Si3402-A-GM to Si3402-B-GM EVB Modifications
Version 0.4

Table 1. Si3402-B-GM EVB modifications versus the Si3402-A-GM EVB

Si3402 (Buck, Non-Isolated) EVB Reference Design - 5V

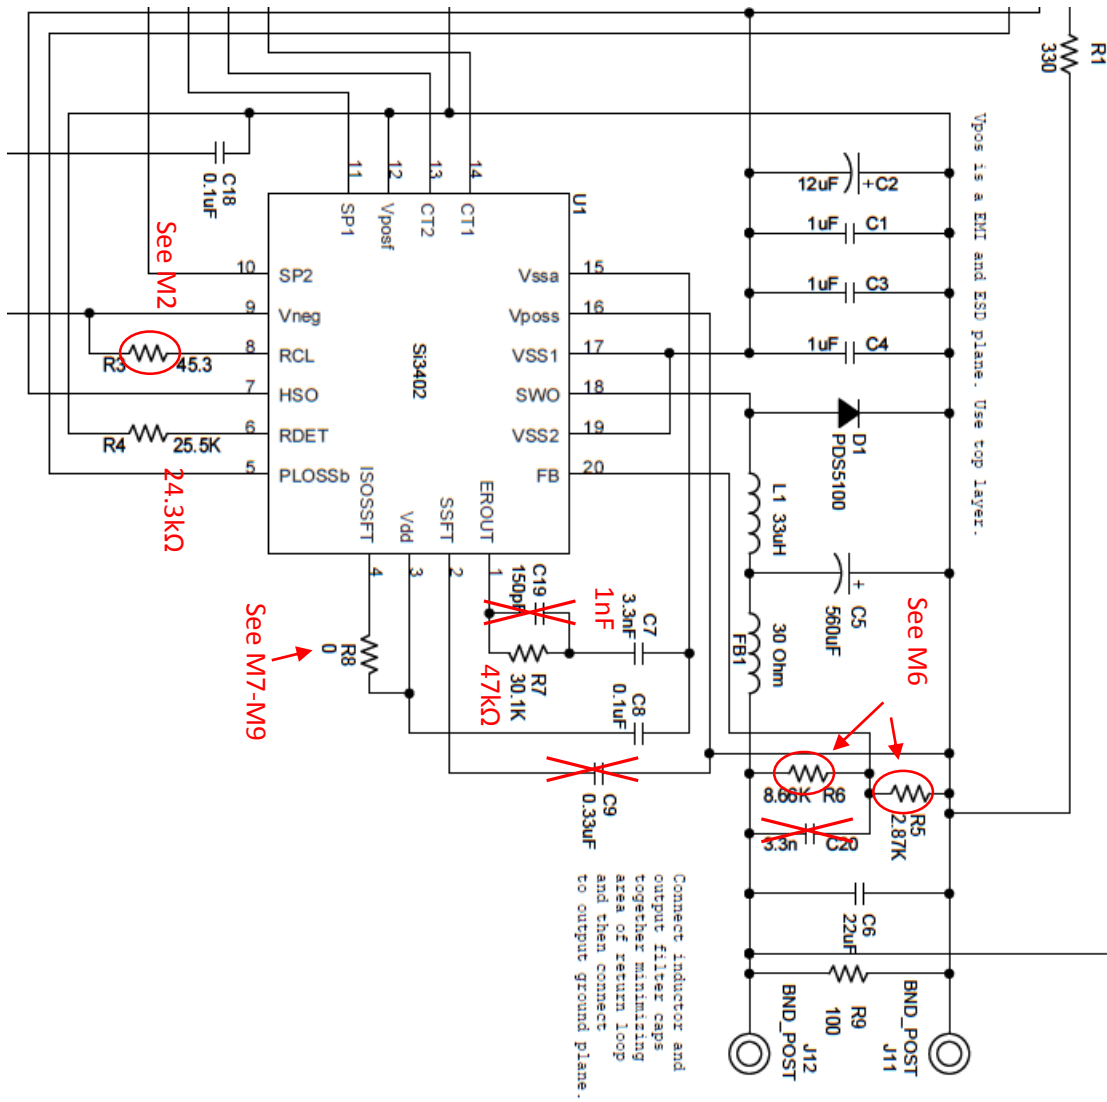
Item	Modification description	Application design effect
M1	Detect resistor value change	The former 25.5k Ω detect resistor must be replaced by 24.3k Ω 1%
M2	Classification resistor value change	The following 1% resistors must be used: Class0: 681.00 or higher (It is optional to place this resistor) Class1: 140.0 Class2: 75.0 Class3: 48.7 Class4: 33.2
M3*	ISO EVB DCDC 3.3V changes Flyback	C8, R9 & C23 are not need—Do not populate them. C9=10nF, C21=33nF, R12=475 Ω & R8=1.1k Ω Replace D2 (DFLT15A) with DFLT30A * See Revision Notes
M4	ISO EVB DCDC 5V changes Flyback	C8, R9 & C23 are not need—Do not populate them. C9=3.3nF, C21=15nF, R12=0 & R8=0 (place zero Ω resistors) Replace D2 (DFLT15A) with DFLT30A
M5	ISO EVB DCDC 12V changes Flyback	C8, R9 & C23 are not need—Do not populate them. C9=10nF, C21=15nF, R12=0, R8=0 (place zero Ω resistor) R7=3k Replace D2 (DFLT15A) with DFLT30A
M6	DCDC reference voltage change (Buck case only)	Now 1.35V instead of previous 1.23V. Thus, R5 changes from 2.87k Ω 1% to 3.24k Ω 1%. R6 (1%) is modified according to this table:

Vout Target	R5 kΩ	R6 kΩ	Vref	Vout Measured	3.3	3.24	4.64	1.35	3.37	5	3.24	8.66	1.35	4.96	9	3.24	18.2	1.35	8.93	12	3.24	25.5	1.35	11.98
Vout Target	R5 kΩ	R6 kΩ	Vref	Vout Measured																							
3.3	3.24	4.64	1.35	3.37																							
5	3.24	8.66	1.35	4.96																							
9	3.24	18.2	1.35	8.93																							
12	3.24	25.5	1.35	11.98																							
M7	BUCK EVB DCDC 3.3V compensation network changes	C19, C20 & C9 are not need—Do not populate them. R8 can be populated with a 0Ω resistor (creating a short between pins 3 and 4) or left unpopulated, since the ISOSSFT function is now internal (see datasheet). C7=1nF, R7=47kΩ ±20%.																									
M8	BUCK EVB DCDC 5V compensation network changes	C19, C20, R8 & C9 are not need—Do not populate them. R8 can be populated with a 0Ω resistor (creating a short between pins 3 and 4) or left unpopulated, since the ISOSSFT function is now internal (see datasheet). C7=1nF, R7=47kΩ ±20%.																									
M9	BUCK EVB DCDC 12V compensation network changes	C19, C20, R8 & C9 are not need—Do not populate them. R8 can be populated with a 0Ω resistor (creating a short between pins 3 and 4) or left unpopulated, since the ISOSSFT function is now internal (see datasheet). C7=1nF, R7=47kΩ ±20%.
